Delegated Report

Householder Planning Application

Planning Application No: 20230765

Description: Erection of a single side and front extension with engineering works to create a front driveway with vehicular access.

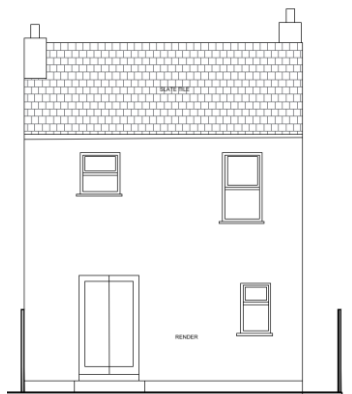
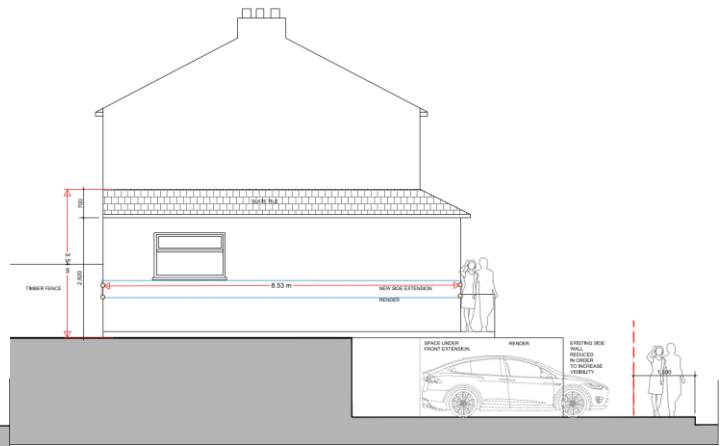
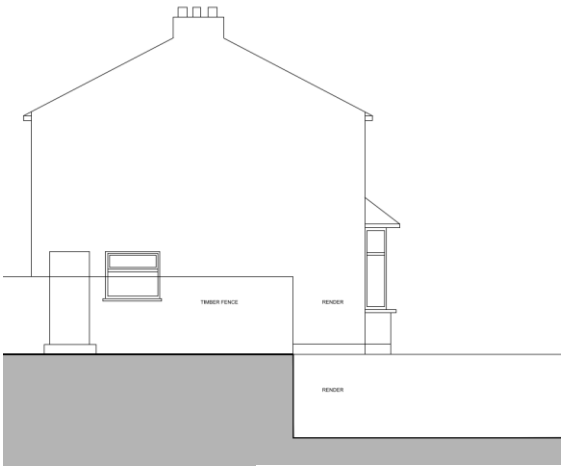
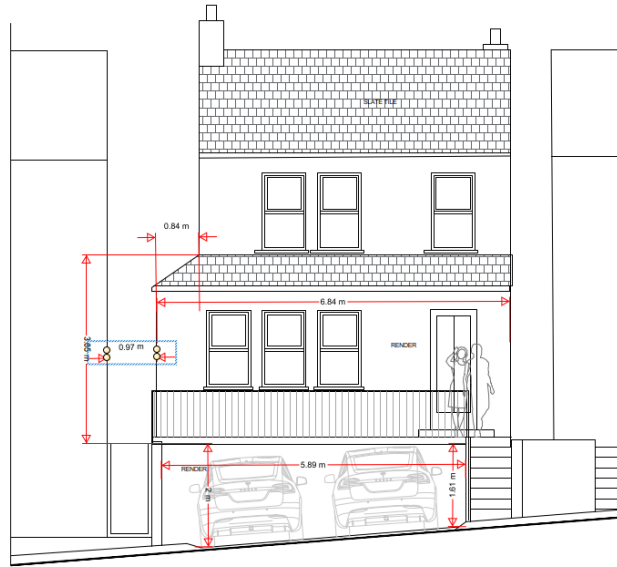
1. Given the span of the cantilevered slab, there may be a need for an intermediate support or thickening of the supporting walls which could conflict with the parking area and the need to have sufficient space to open the doors to gain access. *(Building Control)*. The minimum width of the parking area should be 5.4 metres to comply with KCC SPG4.

2. The section shows a height of 2 metres under the slab, but as the property is on a hill this is only at one point and the height seems to range 1.64 metres (5ft 4.5") and 2.13 metres. 1.64 metres is not practically practicable for a tall person as they will have stoop down. To provide a reasonable head clearance it would be appropriate to have 2 metres as a minimum. Also 1.64 metres provides minimal clearance for some modern SUV's. A Toyota Yaris Cross can be up to 1.590 metres tall, Whilst Land Rover Discovery can be 1.888 metres tall, so allowing a 75mm clearance this increases the minimum height to 1.963m or rounding up 2m.

3. Similarly, the section shows a deep of 5.2 metres that this would appear to vary across the parking area as the highway is not parallel to the property. SPG4 requires a minimum of 5 metres, which may require some deepening of the undercroft element of the parking area, although it has to be recognised that 4.8 metres is a nationally accepted minimum depth of a parking space.

Given the parking area should be capable of accommodating a wide range of vehicles I would recommend that the height of the parking area should be 2 metres minimum, the width is 5.4 metres for both cars and the depth 5 metres minimum but ideally 5.5metres to provide some pedestrian access around the entire vehicle. An informative should be added that due to the busy nature of Vale Road at times all vehicles should be reversed into the parking area to comply with the guidance of the Highway Code Rule 201.

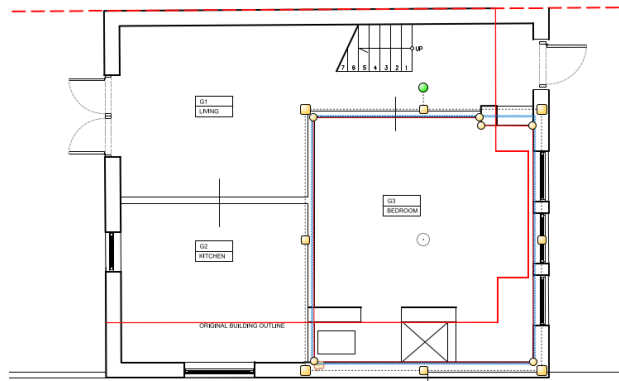
The proposed floor plan does not show an entrance door into the ground floor bedroom and clarity is required regarding this floor plan as there are some unexplained lines on the plan, should permission be forthcoming the agent will be asked to revise this plan.

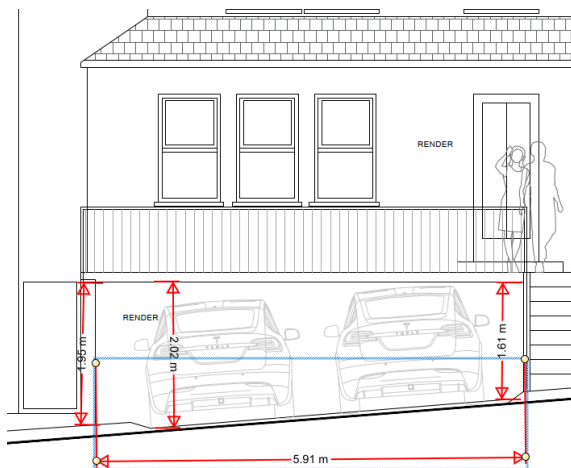
The proposed development will introduce two off road parking spaces to the front of the property but as shown the below plan the depth of the parking is achieved by excavating under the dwelling. However, due to the slope of the property the right hand space is only 1.61m in height which would result in the space being unusable for vehicles. This is demonstrated below where the image shows the vehicle touching the

roof of the dwelling.
